Proposed Revisions to a Standard Plans Index

Index Number: 700-031

Sheet Number (s): 2 of 2

Index Title: External Lighting for Signs

LUMINAIRE SUPPORT STRUCTURE

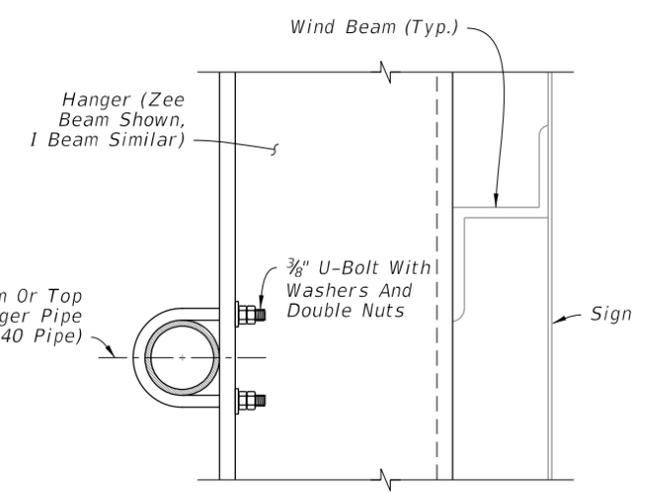
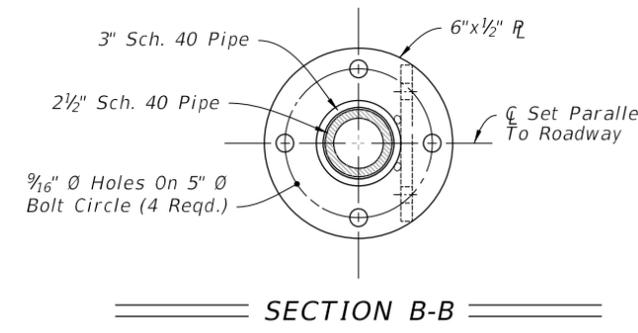
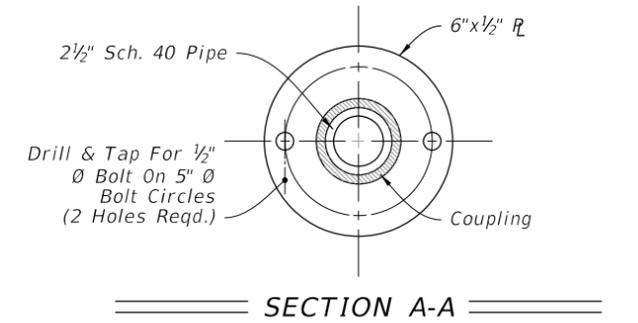
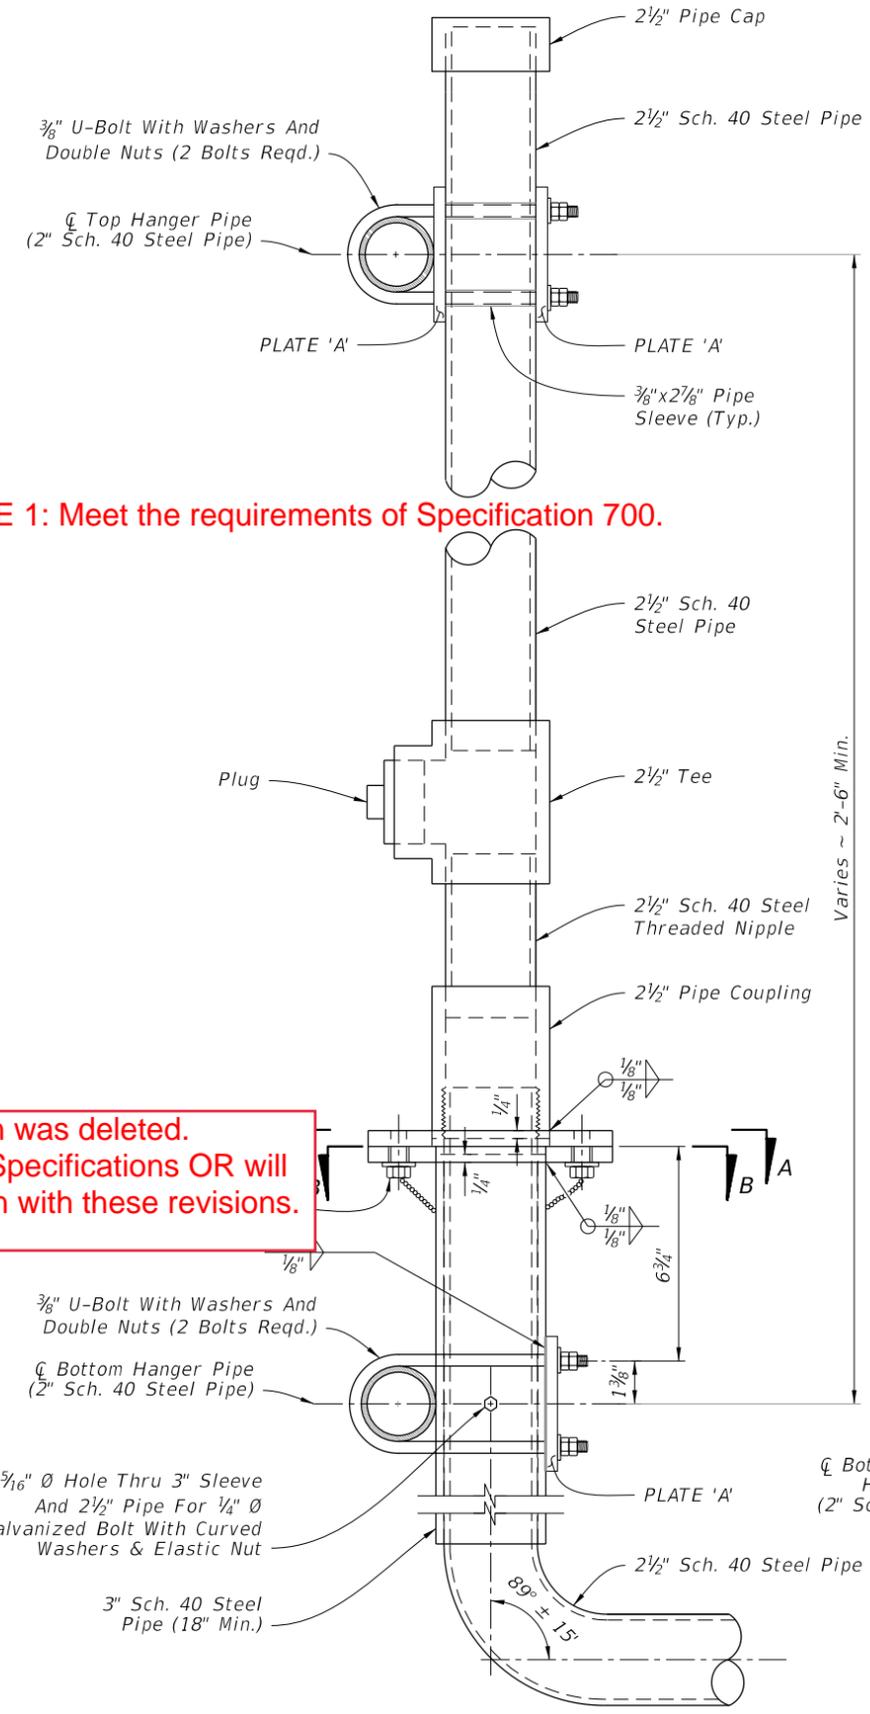
- ADDED NEW NOTE 1: Meet the requirements of Specification 700.**
- 1. NOTES**
- ~~1. Install hanger pipe to each vertical beam crossed with a 3/8" U-Bolt, lock washers and hex nuts. Cap both ends of the horizontal pipe.~~
 - ~~2. Materials;~~
 - ~~A. Steel Pipe: ASTM A53 (Grade A or B)~~
 - ~~B. Steel Plate: ASTM A36~~
 - ~~C. Bolts: ASTM A307~~
 - ~~D. Hex Nuts: ASTM A563~~
 - ~~E. Washers: ASTM F436~~
 - ~~3. Coating: Hot-Dip Galvanize pipes, plates, structural shapes: ASTM A123. Fasteners and hardware: ASTM A153.~~
 - ~~3. All pipe dimensions are NPS.~~
 - ~~4. Chord O.D. + 5" (Min.)~~

GENERAL COMMENT: Some material information was deleted. Information is either already covered in Standard Specifications OR will be added to Section 700, 962 or 965 in conjunction with these revisions.

Added Note 1 - "Meet the requirements of Specification 700"; Deleted Note 2 and 3; Renumbered Notes.

LUMINAIRE SUPPORT STRUCTURE

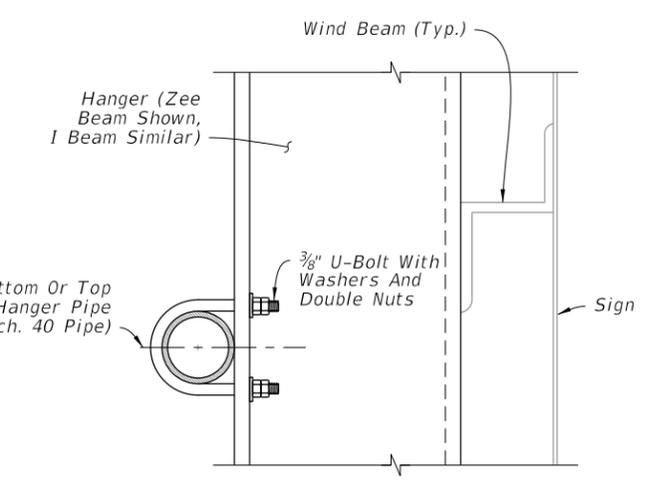
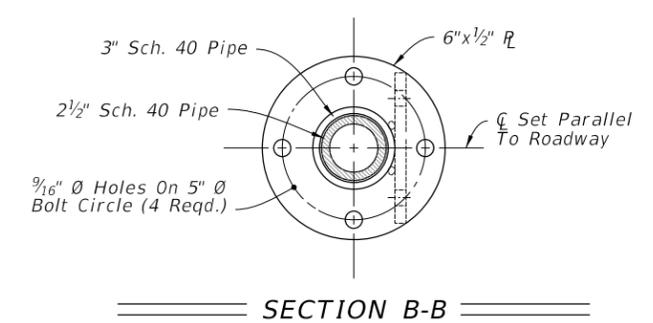
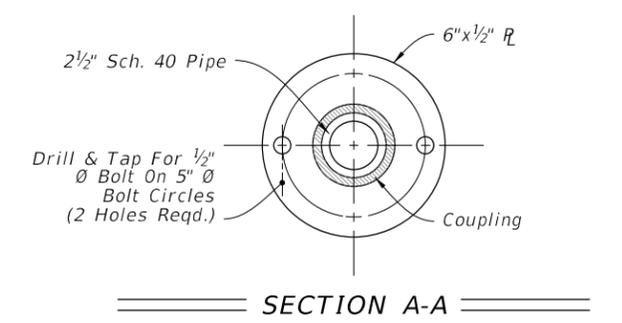
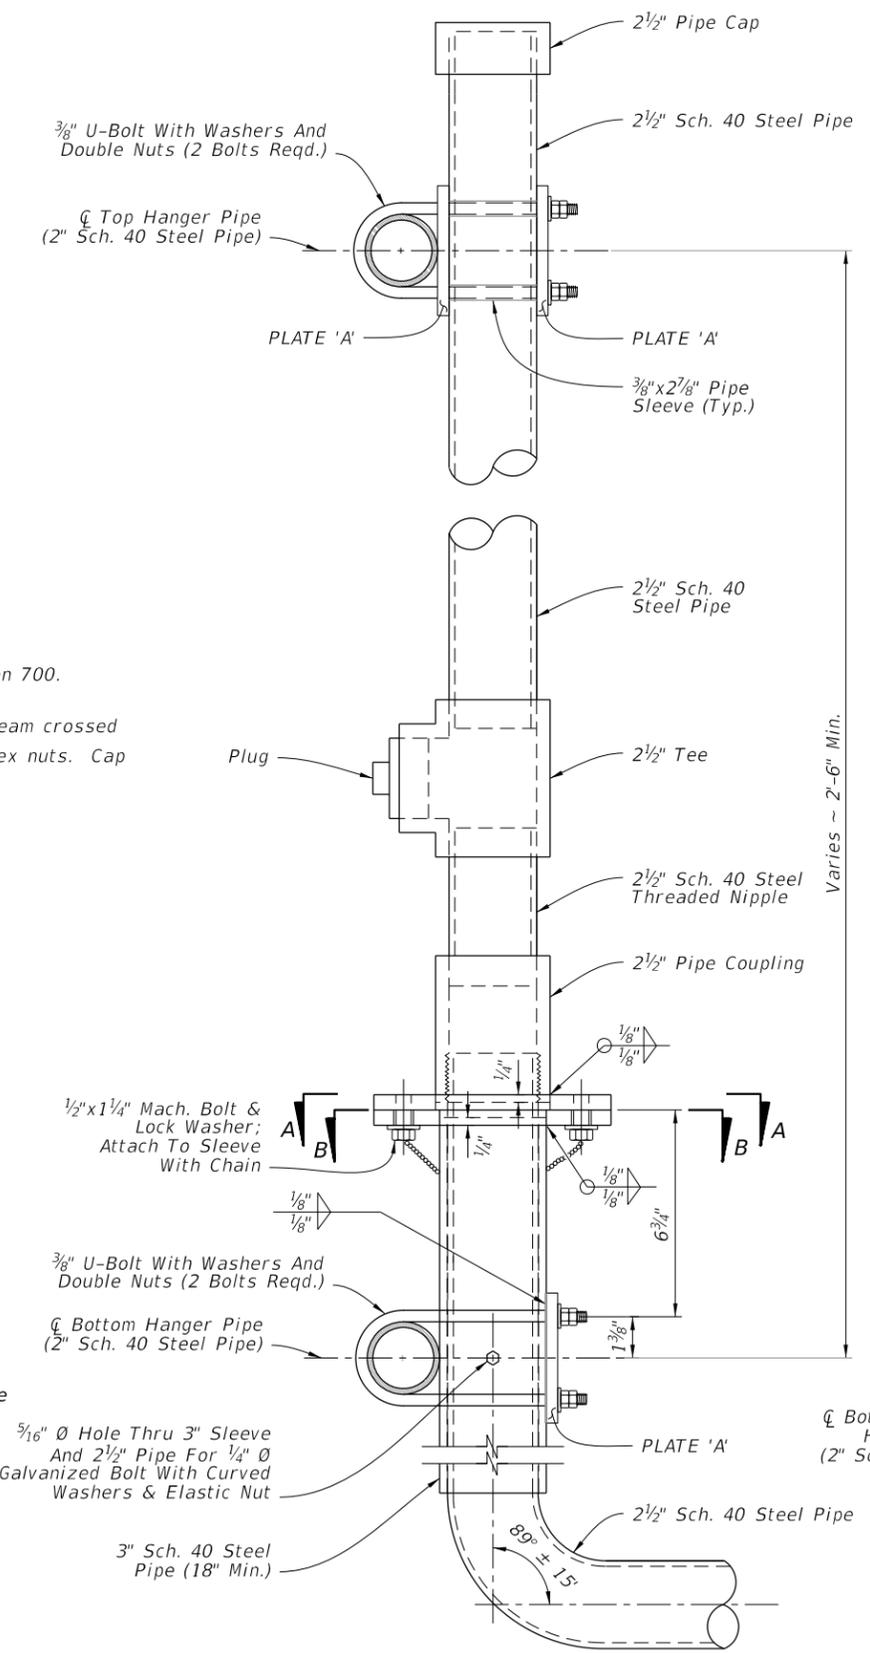
- NOTES:**
1. Meet the requirements of Specification 700.
 2. Install hanger pipe to each vertical beam crossed with a 3/8" U-Bolt, lock washers and hex nuts. Cap both ends of the horizontal pipe.
 3. All pipe dimensions are NPS.
 4. $\frac{\text{Chord O.D.} + 5"}{2}$ (Min.)
